REQUEST

Current Zoning: B-1 (neighborhood business)
Proposed Zoning: MUDD-O (mixed use development, optional) with three-year vested rights

Approximately 0.34 acres located at the southwest intersection of Seigle Avenue and Belmont Avenue, north of Harrill Street.

PLANNING STAFF REVIEW

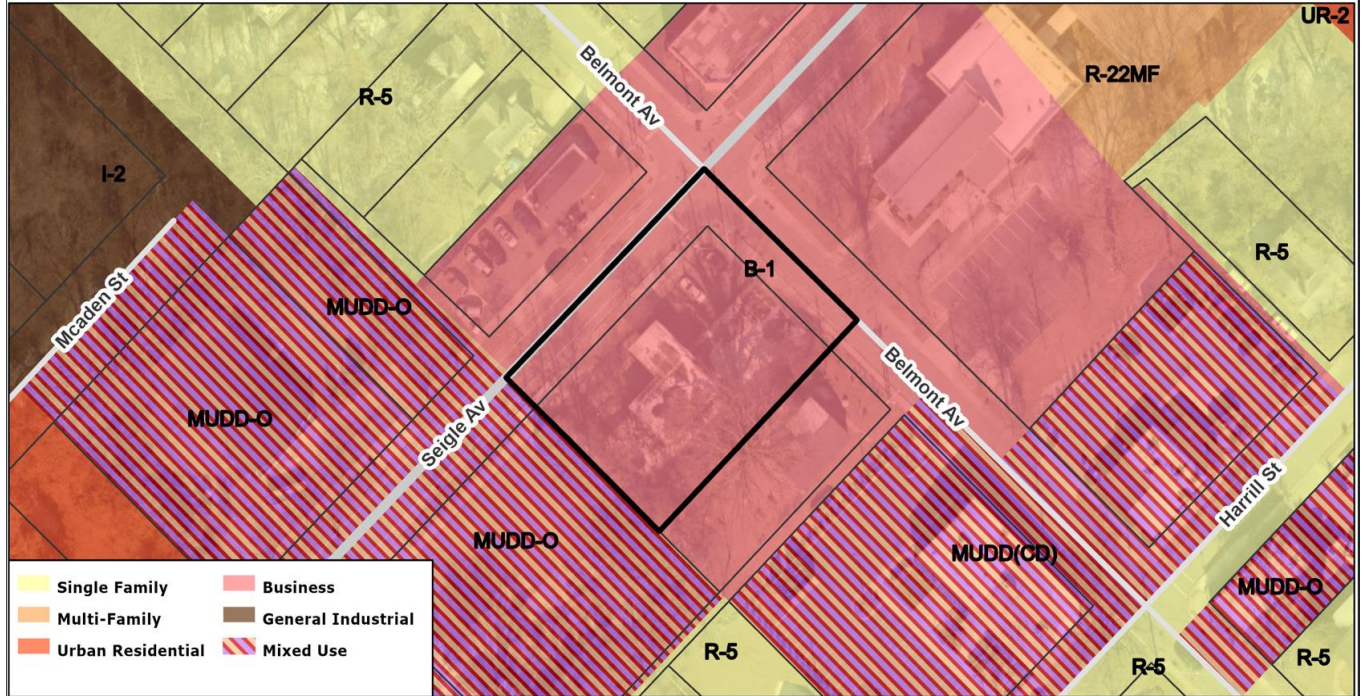
- Existing curb and gutter can remain in existing location but label and dimension the future curb and gutter location from the centerline for each road on the site plan.

- The site plan shall label and dimension the right-of-way from the road centerline. Site plan shows 25' to centerline but does not show the existing 50' from centerline. Label and dimension the existing 50' right of way from centerline of road.

- CDOT REQUESTS petitioner commit to 8' sidewalk and place Streets Map streetscape behind future curb location.
- Add a conditional note specifying "A Right-of-Way Encroachment Agreement is required for the installation of any non-standard item(s) (irrigation systems, decorative concrete pavement, brick pavers, etc.) within a proposed/existing City-maintained street right-of-way by a private individual, group, business, or homeowner's/business association. An encroachment agreement must be approved by CDOT prior to construction/installation. Contact CDOT for additional information concerning cost, submittal, and liability insurance coverage requirements."

- Add a conditional note specifying "the Petitioner shall dedicate and convey in fee simple all rights-of-way to the City before the site's first building certificate of occupancy is issued. CDOT requests rights-of-way set at 2' behind back of sidewalk where feasible."

6. Petitioner should revise the site plan and conditional notes to show sidewalk utility easement on plans behind proposed sidewalk.
7. Petitioner should revise the site plan and conditional notes to show 10x10 triangles behind the sidewalk.

8. Review urban tree requirements. While the 10' no build zone can be counted towards tree save there must still be a minimum of 10' of replanted tree save. (20' total width) Trees cannot be planted within 10' of a structure/retaining wall. Utilities such as transformers are not permitted within trees save or amenitized tree save.
9. Trees outside of the property line cannot count towards any requirements. Trees must be completely on the property to count towards requirements.

10. Please confirm if residential is proposed as it is not specified under proposed uses.
11. Under proposed list of permitted uses, please modify Type EDEE Types 1 and 2 to note subject to ordinance requirements.
12. Under proposed list of permitted uses, please modify breweries to note subject to ordinance requirements.
13. Include minimum % brick required on ground floor.
14. Include minimum area for public open space required.
15. The precedent imagery is showing a structure constructed with brick. Recommend brick being used as a primary building material on the first floor.
